Project	<b>IEEE 802.16 Broadband Wireless Access Working Group</b> < <a href="http://ieee802.org/16">http://ieee802.org/16</a> >
Title	<b>CR on SDD Section 17: Load Balancing between Femto and Macro BS</b>
Date Submitted	<b>2009-02-24</b>
Source(s)	Karthik Sundaresan, Sampath Rangarajan, <a href="mailto:karthiks@nec-labs.com">karthiks@nec-labs.com</a> Linghang Fan, Nader Zein, Tetsu Ikeda, Andreas Maeder, Amir Khojastepour, Mohammad Madihian  NEC
Re:	Change request to Project 802.16m System Description Document (SDD) (IEEE 802.16m-08/003r7)
Abstract	This contribution provides text addition to SDD to facilitate load balancing between femto, micro and macro BS in the network.
Purpose	For discussion and approval by IEEE 802.16m TG
Notice	<i>This document does not represent the agreed views of the IEEE 802.16 Working Group or any of its subgroups. It represents only the views of the participants listed in the "Source(s)" field above. It is offered as a basis for discussion. It is not binding on the contributor(s), who reserve(s) the right to add, amend or withdraw material contained herein.</i>

## Load Balancing between Femto and Macro BS

Figure 1a. Traffic concentration in femto cells.

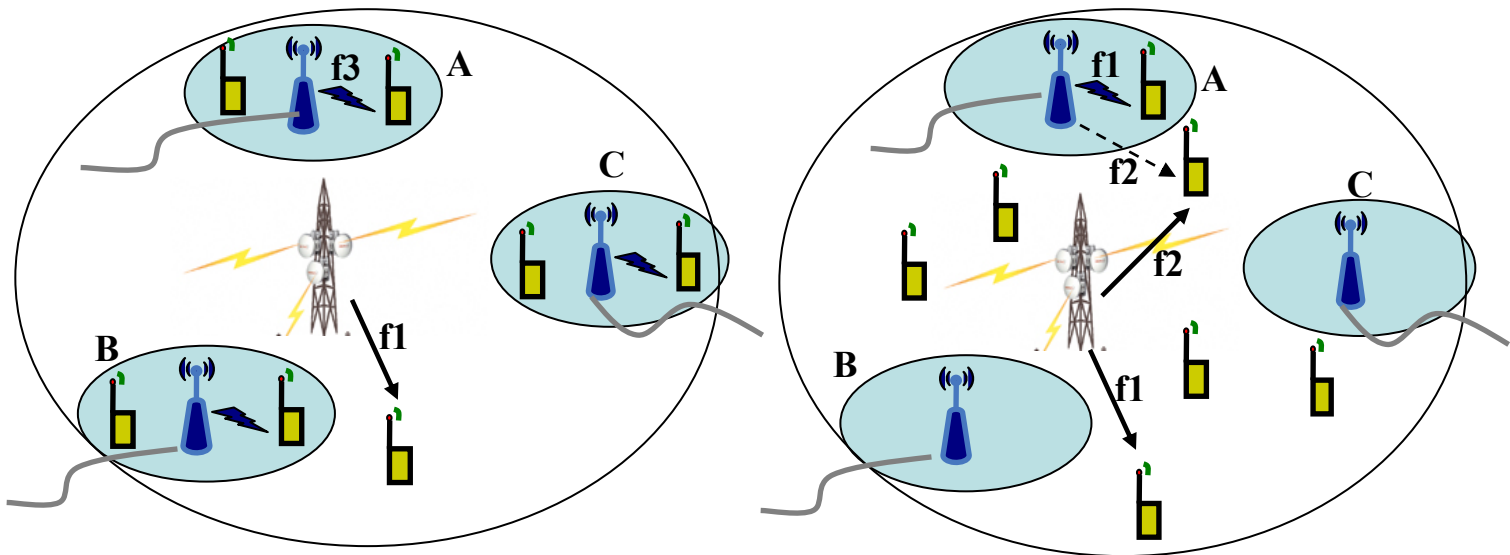
Current SDD text mentions that femto BS can coordinate with the macro BS or autonomously determine the resources to be used for its operation. Irrespective of which method is adopted, it does not currently provide provisions for load balancing between the femto and macro BS. Given the usage scenarios of femto cells in residences, enterprises, complexes, etc. it can be anticipated that the dynamics of traffic in these femto cells can vary significantly depending on the time of the day. For eg, one can expect more traffic from residential femto cells during the evenings. Given the large dynamic nature of load in these femto cells, it is very important for the service provider to coordinate the resources between macro and femto cells so that the resources are efficiently utilized contributing to better revenue. For eg. consider the scenario is Fig 1a and 1b. In Fig. 1a, the UE concentration is more in the femto cells compared to the macro, while in 1b it is the macro cell where traffic is concentrated. Using the same allocation of resources for both the scenarios will lead to poor utilization of resources and hence performance. For the scenario is 1a, more resources must be allocated towards the femto cells, while for 1b more resources must be allocated to the macro cell.

To address this load balancing scenario, it is important for some coordinating entity (say macro BS) to periodically collect some traffic performance metric (load, utility, etc.) from the macro and femto BS to decide on the amount of resources that can be allocated to the macro BS and the femto BS. How the macro and femto BS decide to use these resources is not within the scope of this document. However, being able to periodically collect traffic metrics from them will help efficiently balance the load between them and adapt it to varying network dynamics. The periodicity (semi-static nature) of such information collection could also be implementation dependent.

### 17.12 Load Management and Balancing

It is important to efficiently balance the load between the macro and femto BS to optimize capacity and QoS. To achieve this, some traffic performance metric (load, utility, etc.) should be periodically collected from the macro and femto BS to decide on the amount of resources that will be used by the macro, micro and the femto BS. How the macro and femto BS decide to use these resources in a distributed manner is not within the scope of this document. However, being able to periodically collect traffic metrics from them will help efficiently adapt and balance the load between them and adapt it to varying network dynamics. The periodicity (semi-static nature) of such information collection could also be implementation dependent.
